# **Wellington North Power Inc.**

2014 Distribution Rate Application

Response to Board Staff Interrogatories

OEB File Number: EB-2013-0178

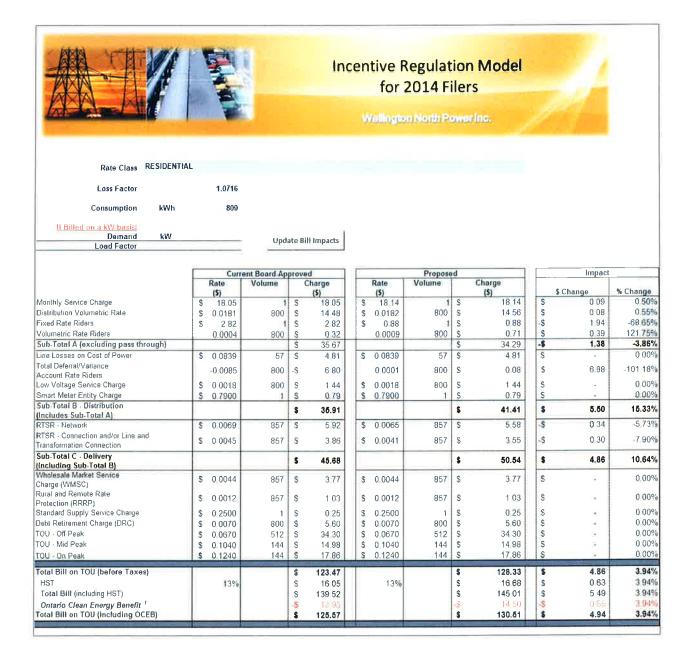
On Sheet C1.1 of the Incremental Capital Workform, WNP has indicated that it has a combined 43 customers in the General Service 50 to 999 kW and General Service 1,000 to 4,999 kW classes, combined. WNP's 2011 2.1.5 RRR filing indicates 45 customers for those two classes combined.

a) Please confirm the customer numbers for the GS > 50 kW classes. If the numbers are in error, please provide the correct customer numbers for the 2011 year and Board staff will make the appropriate changes to the model

WNP has updated sheet "C1.1 Ld Act-Mst Rcent Yr" of the Incremental Capital Workform to show 40 customers Service 50 to 999 kW and 5 customers for Service 1000 to 4999 kW, a combined total of 45 customers as table below:

It should be noted that by updating rate class General Service 50 to 999 kW from 38 customers to 40 customers, the **Service Charge Revenue** and consequently the **Total Revenue by Rate Class** amounts have increased compared to the values that were originally filed by WNP. The

impact of these Revenue changes (increases) has resulted in the growth percentage changing to 1.15% (previously 1.44% as per initial IRM application) as shown in sheet "E1.1 Threshold Parameters" of the Incremental Capital Workform.

#### 2.4 Mt. Forest MS-4 Substation

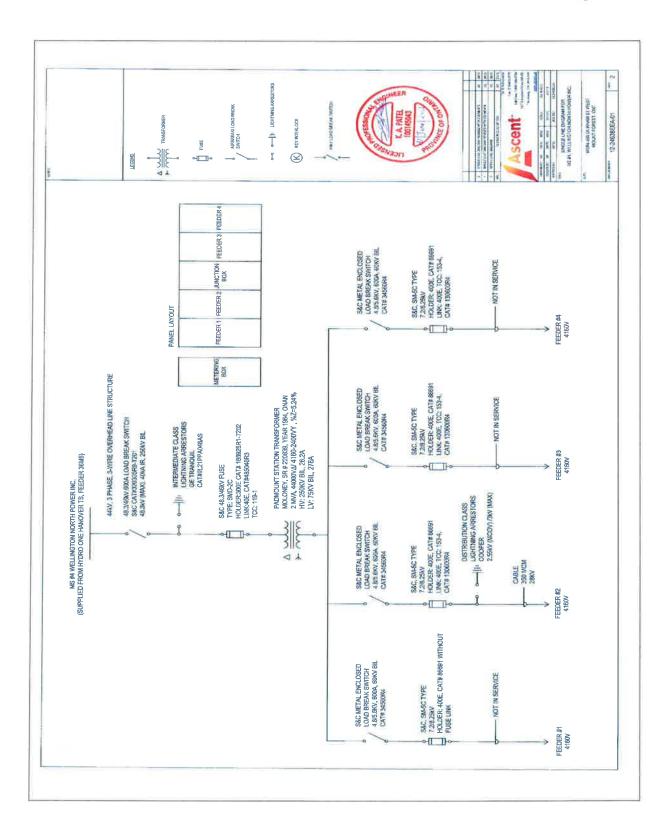
a) Please provide the detailed substation assessment findings and information relevant to Substation MS-4 in the Costello Associates report that was not included in the Application.

The Mt. Forest substation is the oldest of the utility at an age of 49 years, it also shares many of the same issues as other stations in terms safety and shows signs of age. It does although contain a much more serious issue. The system neutral has been attached only to the station ground grid, which in extremely dangerous, Due to this fact, it was recommended that the station be de-energized during inspection. The neutral system must be re-engineered prior to re-energization.

Inspection revealed that other equipment deficiencies are also present. The transformer secondary side cables are improperly installed and are putting pressure on the transformer radiator. Furthermore, test results also suggest that there are problems with feeder cables.

Remaining problems found in the station are similar as in the other stations. There are missing locks on power transformers and distribution-side switchgear, wiring code violations, bonding and grounding issues and operating nomenclature must be updated.

The station is classified as "Red" due to the age of the transformer, the system neutral connection, and diagnostic test results. This station is a candidate for replacement.
